ENGINEER'S SUPPLEMENTAL INSTRUCTIONS NO. TWELVE (12)
(Via Posting to FTP Site and Electronic Mail)

RE: Harold D. Thompson Regional Water Reclamation Facility (HDTRWRF)-Phase 1
ENGINEER'S SUPPLEMENTAL INSTRUCTIONS NO. TWELVE (ESI-012)

The ESI-012 addresses modifications to the project drawings relative to the Pumping and Disinfection Building which were issued September 16, 2011 for preparation of the CMO covering the foundation scope of work. The modifications described in this ESI appear on the Pikes Peak Regional Building Department (PPRBD) foundation only permit submittal drawings. Please distribute this ESI to any and all suppliers and subcontractors so the items described herein may be accounted for in the foundation CMO prepared for the Pumping and Disinfection Building. The following is a list of drawing modifications arranged by sheet number.

1 PUMPING AND DISINFECTION BUILDING DRILLED PIER PLAN
PD-3 SCALE: 1" = 4'

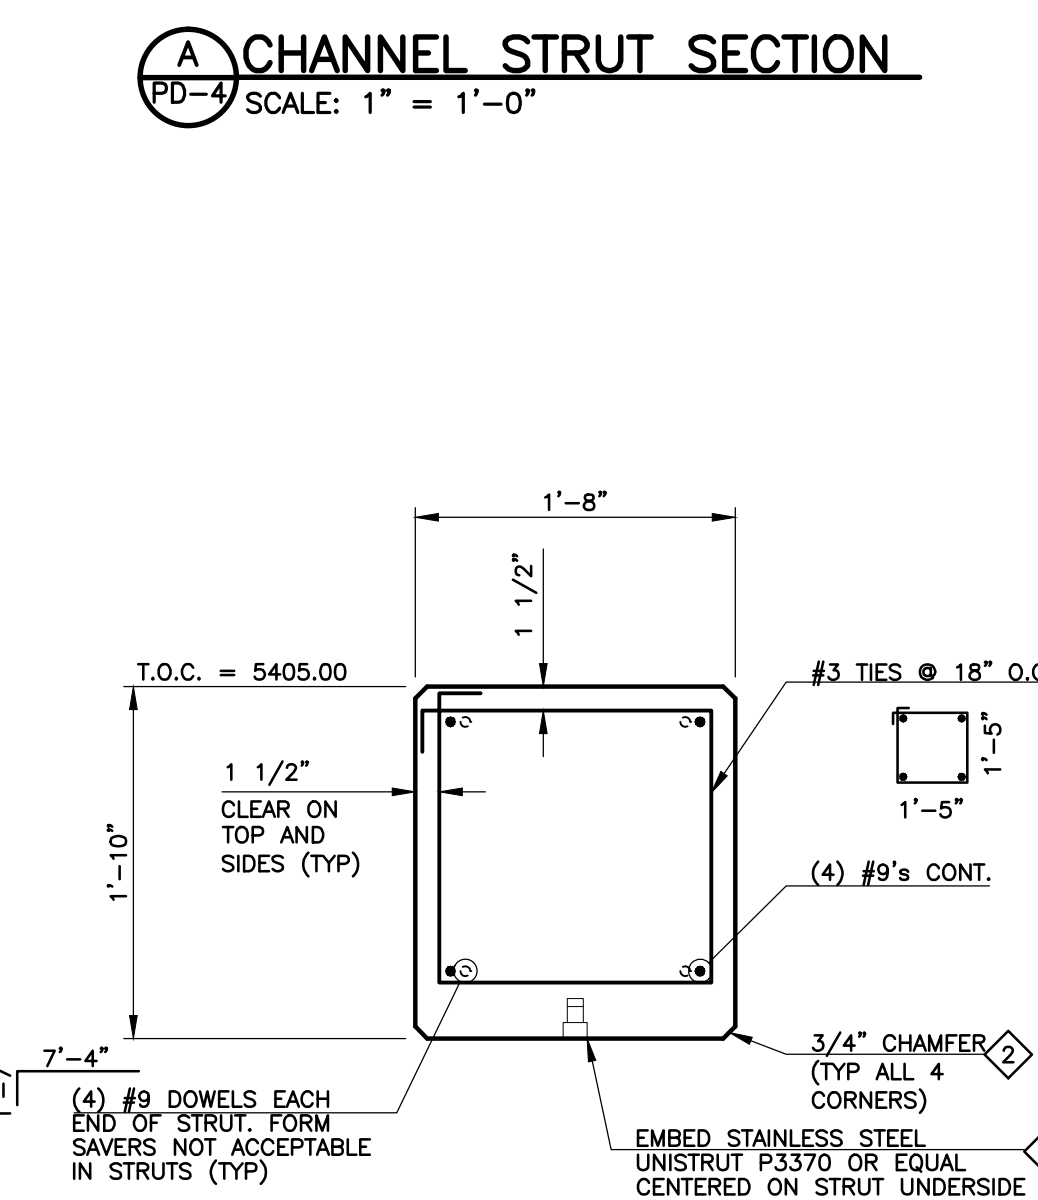
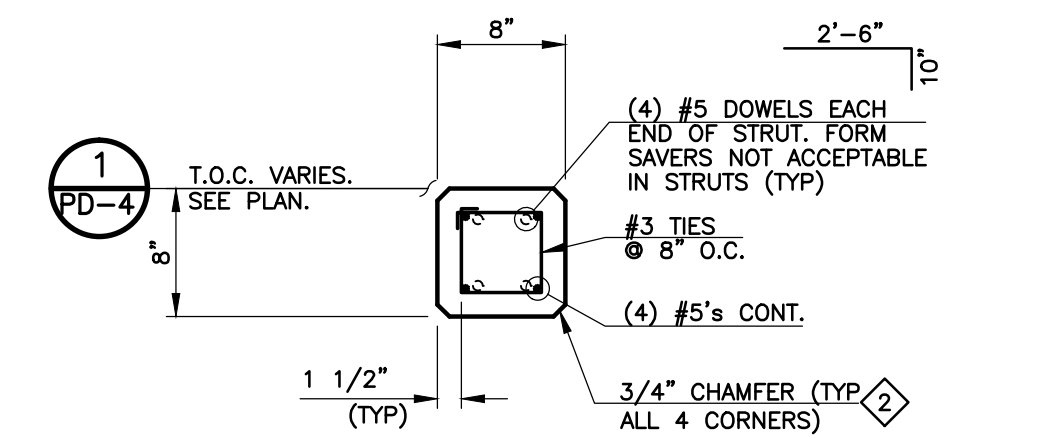
- Sheet PD-3
 - Deleted the drilled pier near the center of UV Channel No. 2
 - Deleted the drilled pier at the southwest corner of the Drain Wetwell
 - Deleted the drilled pier at the southeast corner of the Wastewater Wetwell

- Revised the drilled pier at the southwest corner of the Wastewater Wetwell to provide a minimum penetration into bedrock of 13'-0", and an estimated bottom of pier elevation of 5357.00. In addition, two dimensions have been added to specify the placement of this drilled pier.

- Revised the drilled pier near the center of UV Channel No. 1 to provide a top of pier elevation of 5393.70
 - Revise the drilled pier near the center of the Flume Channel to provide a top of pier elevation of 5393.70

- Revise four drilled piers along the north wall of the Pump Room, and the two westerly drilled piers under the south wall of the Pump Room to provide a top of pier elevation of 5383.46

- Added a new note to the drilled pier near the midpoint of the south building wall indicating the approximate location of the ufer grounding electrode, and referencing the electrical drawings for additional information

1 PUMPING AND DISINFECTION BUILDING FOUNDATION PLAN
SCALE: 1" = 4'

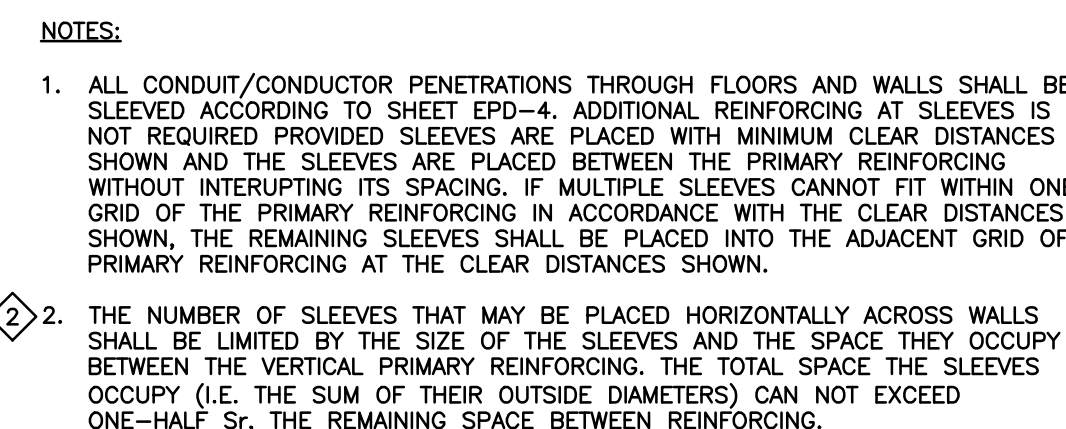
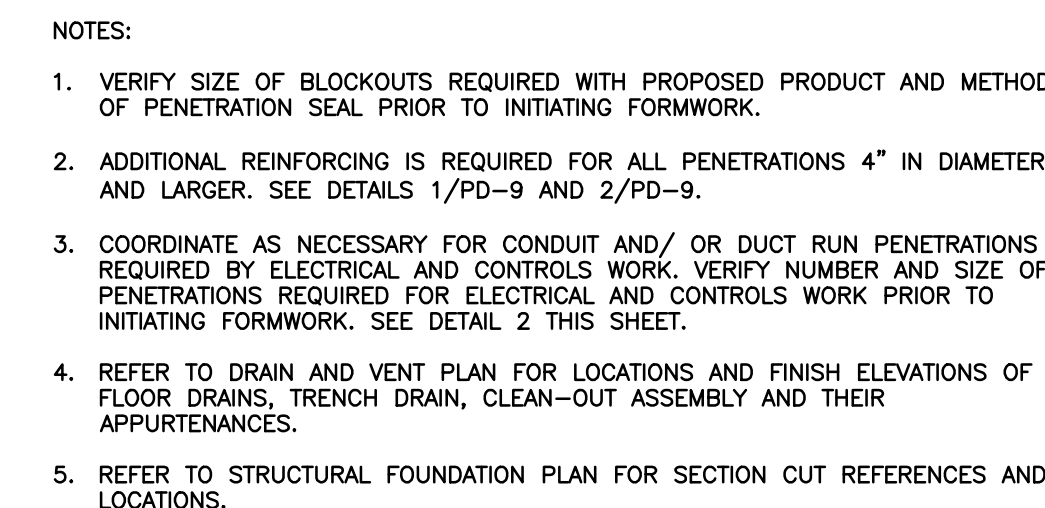
- Sheet PD-4
 - Revise the following sheet notes as described below
 - Note No. 4: revised to clarify ufer grounding requirements
 - Note No. 7: revised to indicate a Hypochlorite Storage and Feed Room ceiling height of 11'-0"

- Note No. 13: new note regarding the rigid insulation requirement on the exterior of deep walls
 - Note No. 14: new note regarding the rigid insulation requirement on the interior of perimeter foundation walls

- Revise Section A to indicate the requirement of a 3/4" chamfer on all four corners of the Channel struts
 - Revise Section B to indicate the requirement of a 3/4" chamfer on all four corners of the Pump Room struts, as well as a stainless steel material for the embedded unistrut

- Revised the Foundation Plan with regards to the Hypochlorite Storage and Feed Room. The boundary of this room is now shown as 6-inches wide to coincide with the requirement of a 6-inch wide by 8-inch high concrete containment curb. A minimum 6-inch high water stop shall be embedded in the floor slab at the center of the containment curb. An 8-inch floor drain has also been added to this room, the floor drain will be required to have a hinged solid cover plate with a lifting chain and hook that will be secured to the adjacent wall. The elevation of the door opening in the south foundation wall to this room has been raised to an elevation of 5405.28 to provide the necessary containment volume.

- Revised the location of the trench drain cleanout near the southwest corner of the building to align with the east edge of the trench drain
 - Revised the Wastewater Wetwell top of slab elevation to 5387.00

SHEET
PD-4A
OF

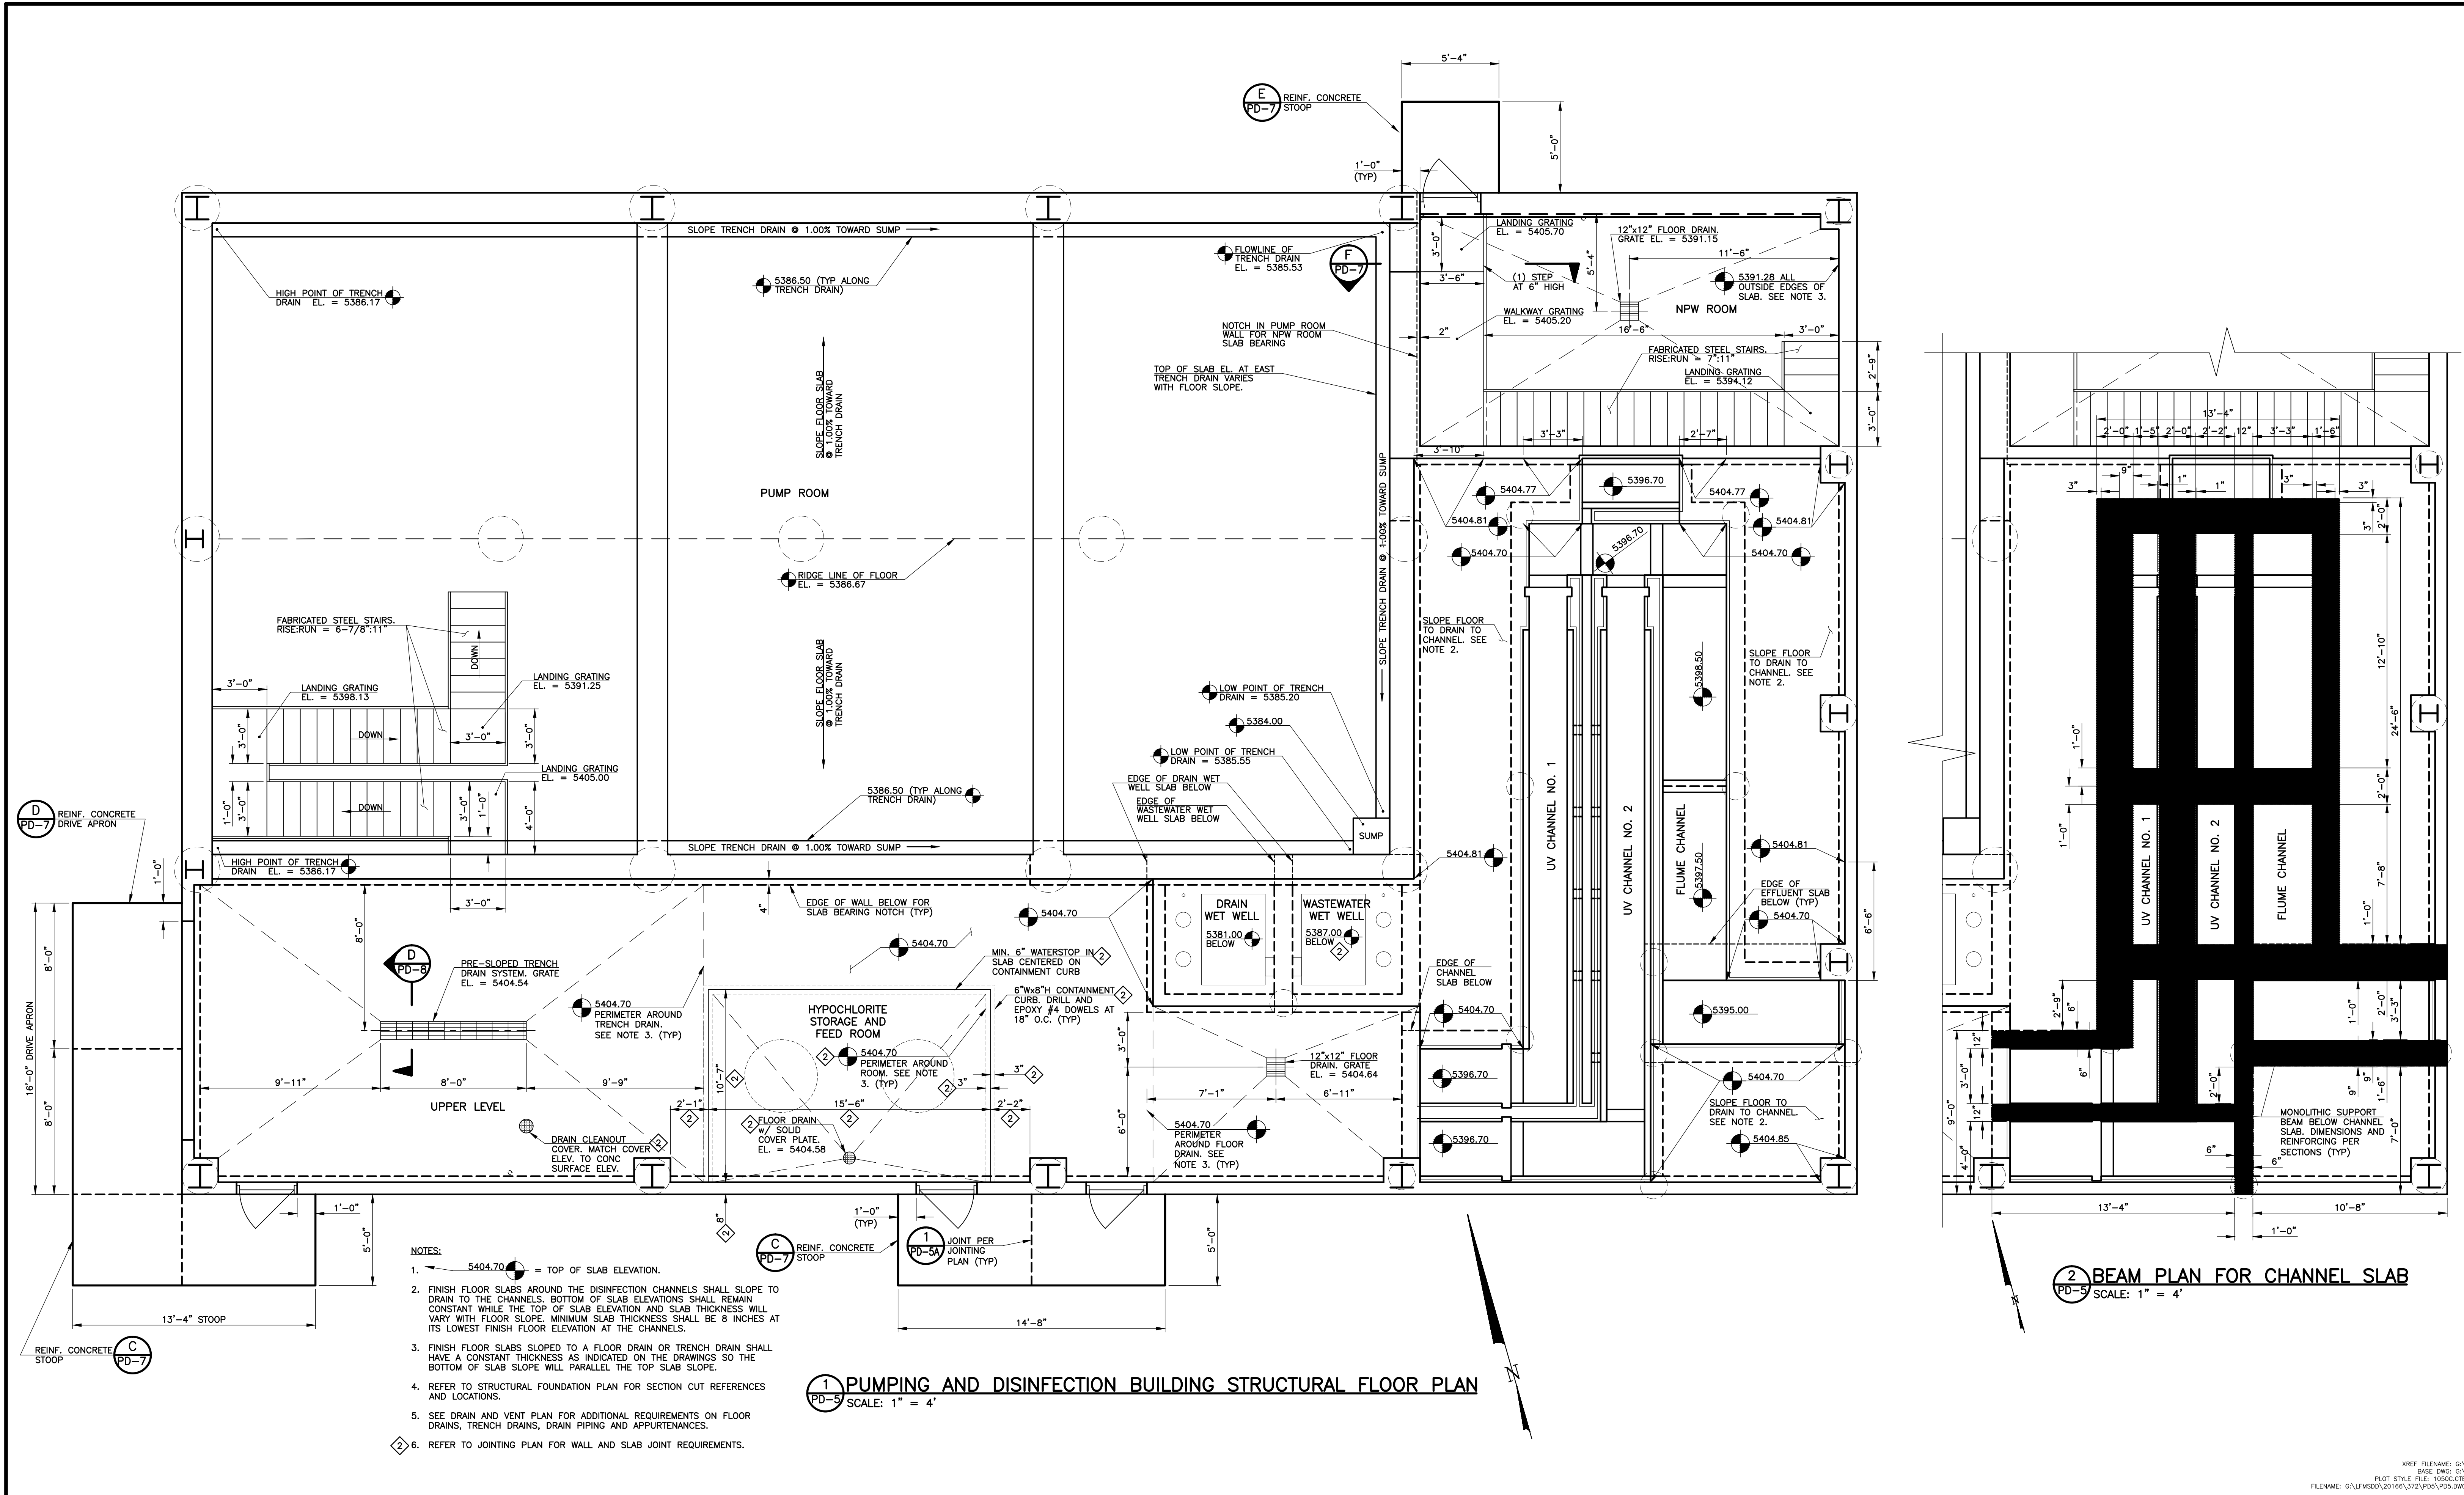
- Sheet PD-4A
 - Revised the Penetration Plan according to the following descriptions:
 - Placed a 12-inch wall pipe in the wall between the Pump Room and the Drain Wetwell, along with a dimension indication its horizontal position

- Placed a 6-inch diameter block out in the wall between the Pump Room and the Drain Wetwell, along with a dimension to indicate its horizontal position

- Added a reference to the new detail, Mud Valve Recess Detail, for the three channel drain pipe penetrations; one in the north end of UV Channel No. 1; one in the north end of UV Channel No. 2; one in the southwest corner of the UV Cleaning Tank

- Revised details relative to the Hypochlorite Storage and Feed Room as described previously for Sheet PD-4
 - Revised Detail No. 2, Typical Sleeve Detail, to clarify the spacing requirements for sleeve penetrations

- Provide a new Detail No. 3, Mud Valve Recess Detail, indicating the installation requirements for the slab penetration at each mud valve installation
